ADDENDUM NO. 1

PROJECT: R18-445 ELLISON COMMUNITY HALL STAIRS - FABRICATE & INSTALL

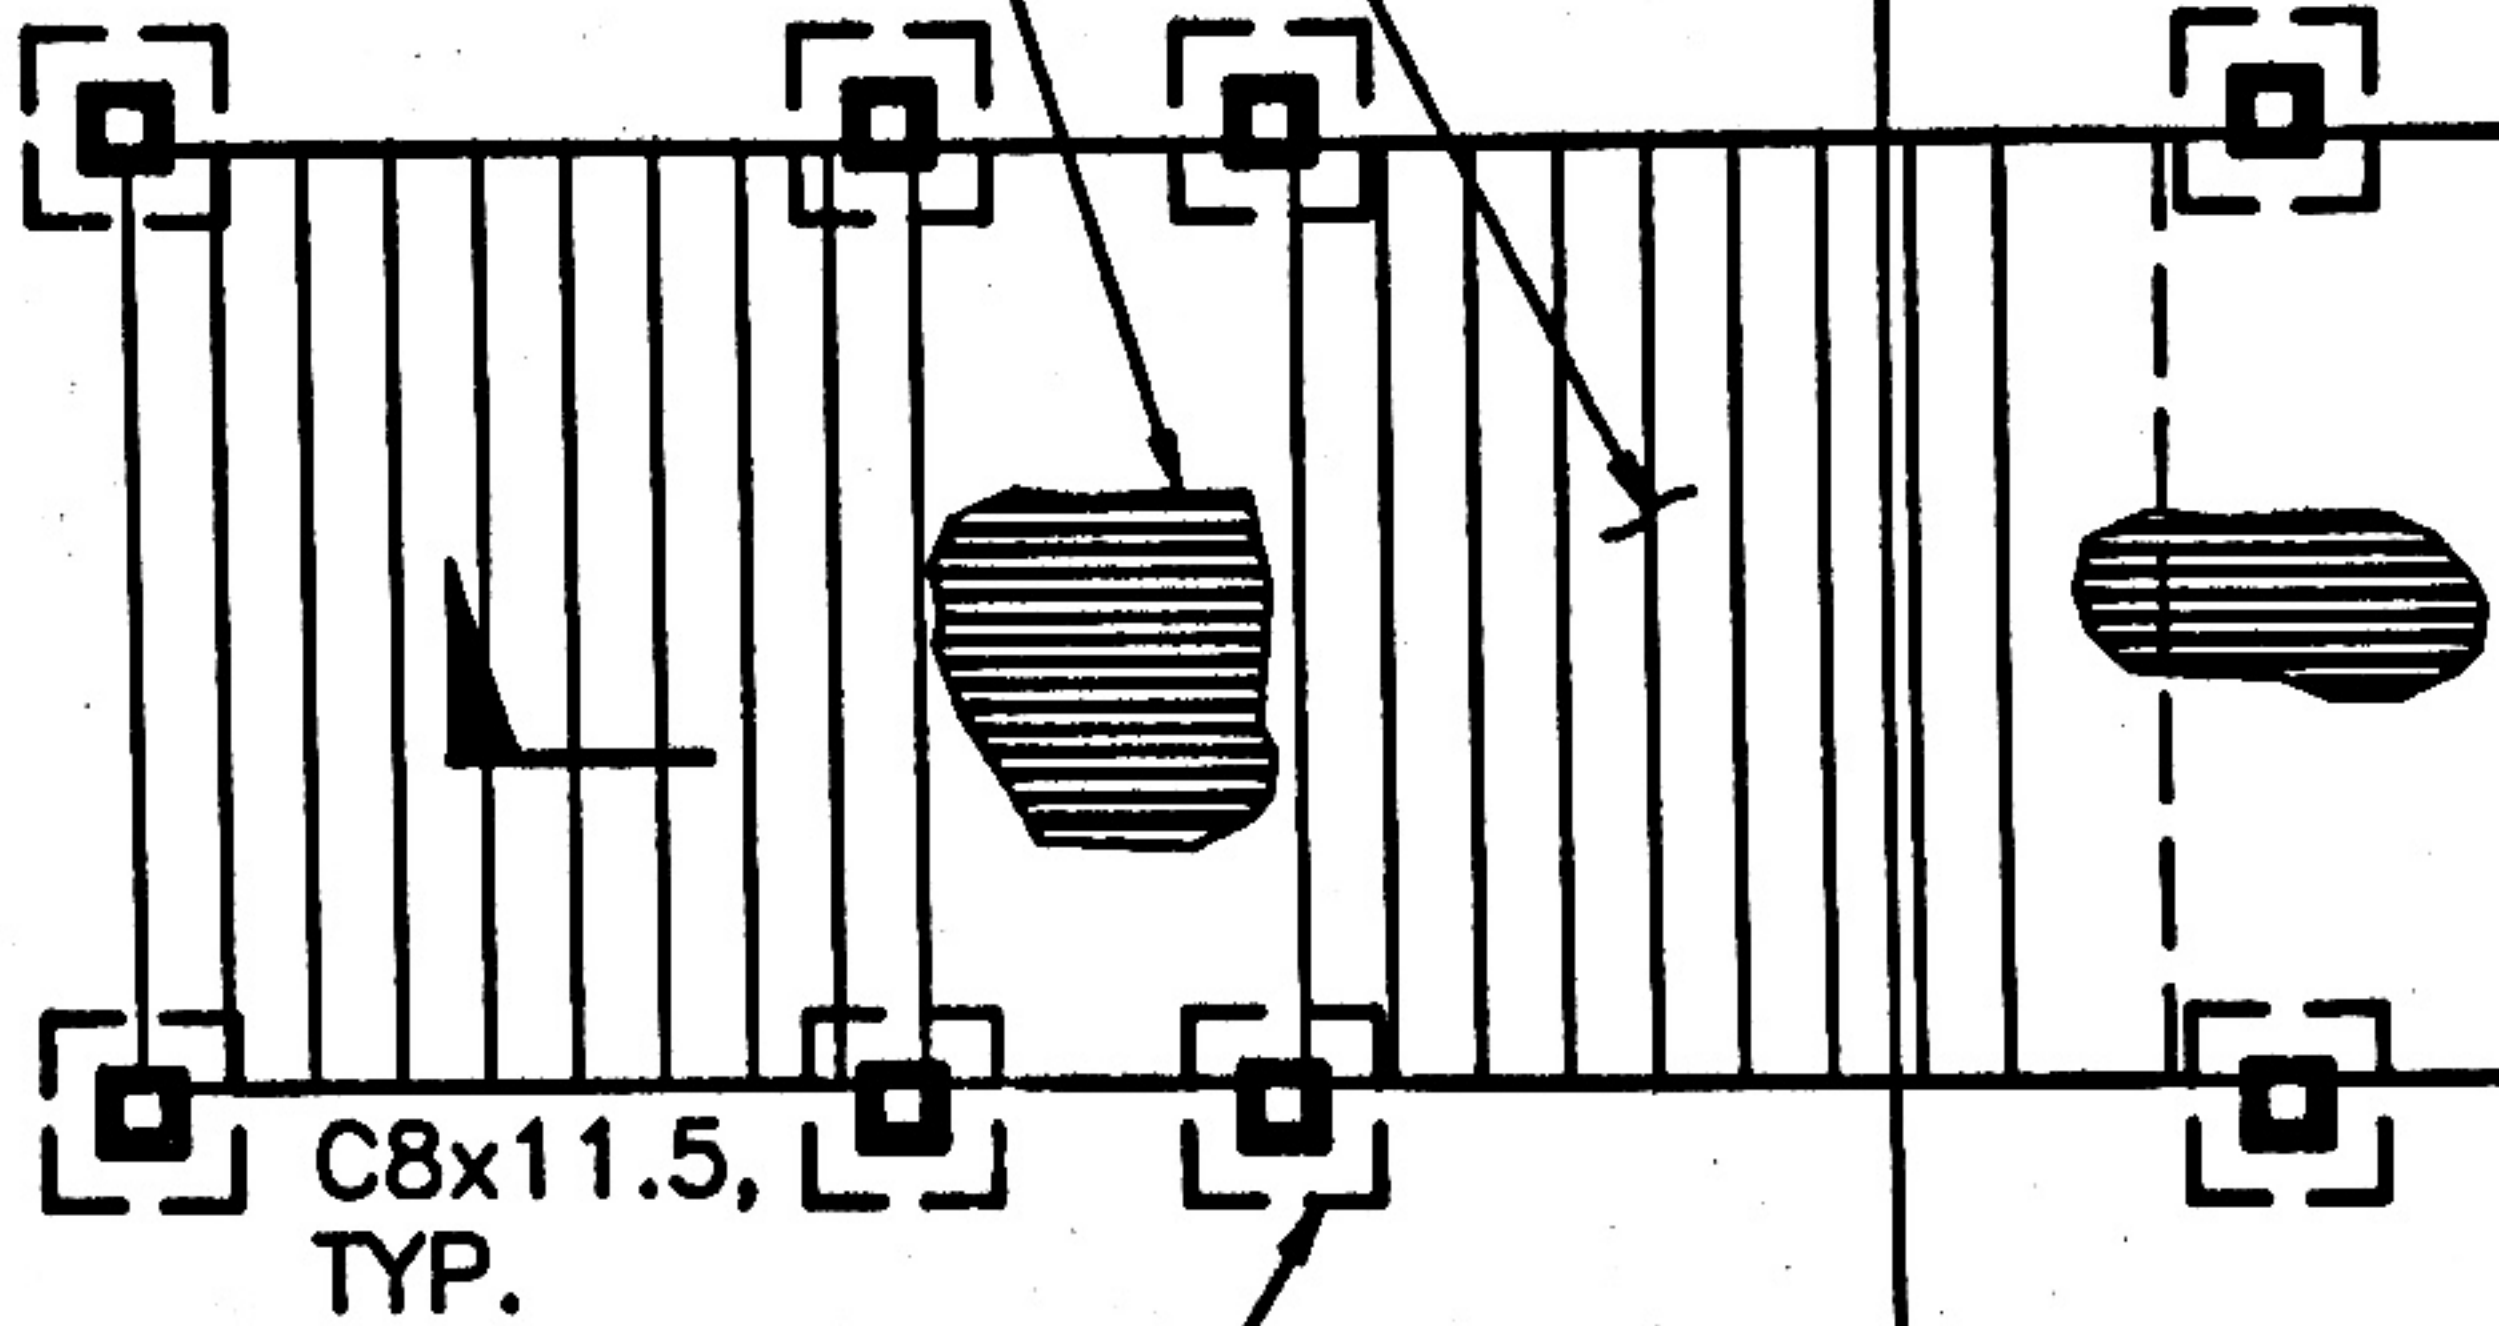
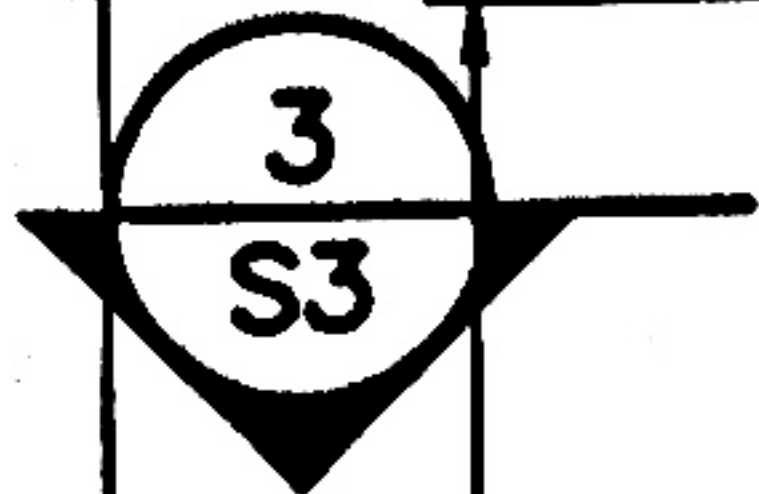
- On site electricity and water is available for use by the contractor during construction.
- Provided is a plan view of existing stairs with additional existing footing details for information. Please note that drawings are provided as an attachment to this Addendum 1 and are provided for reference only and will not form part of the contract documents.
